# PLANNED UNIT DEVELOPMENT & SIDEWALK WAIVER STAFF REPORT Date: December 1, 2005

**DEVELOPMENT NAME** McCrary Automotive Subdivision

**LOCATION** 1445 East I-65 Service Road South

## SITE PLAN

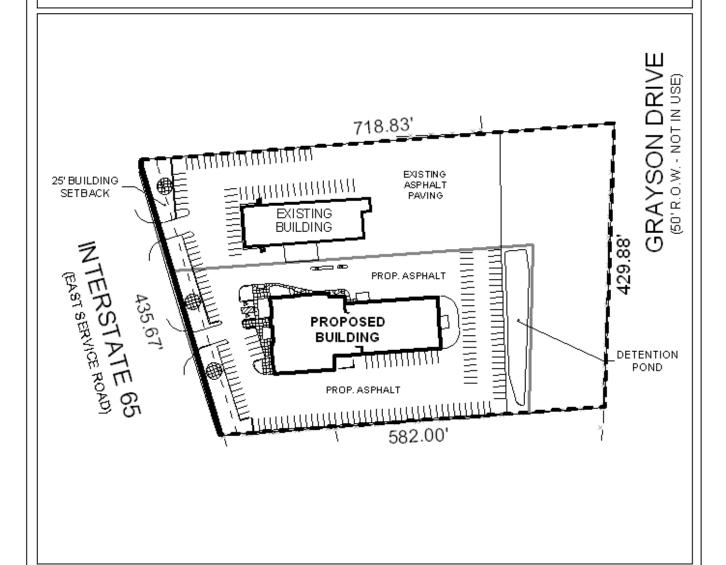
The site plan illustrates parking spaces in excess of the minimum requirements for the buildings shown, and the circulation plan appears to meet the requirements of the Zoning Ordinance.

Regarding the Sidewalk Waiver request, the applicant states that a steeply sloping runoff ditch between the property line and the service road shoulder would prohibit construction of a sidewalk to city standards. This statement is supported by the cross-section provided, and City Engineering has recommended the waiver.

**RECOMMENDATION**Planned Unit Development Based on the preceding, this application is recommended for approval, subject to the following conditions: 1) the completion of the subdivision process prior to the issuance of any permits; 2) full compliance with landscaping and tree requirements of the Zoning Ordinance to be coordinated with Urban Forestry; and 3) full compliance with all municipal codes and ordinances.

Sidewalk Waiver Based on the preceding, this application is recommended for approval.
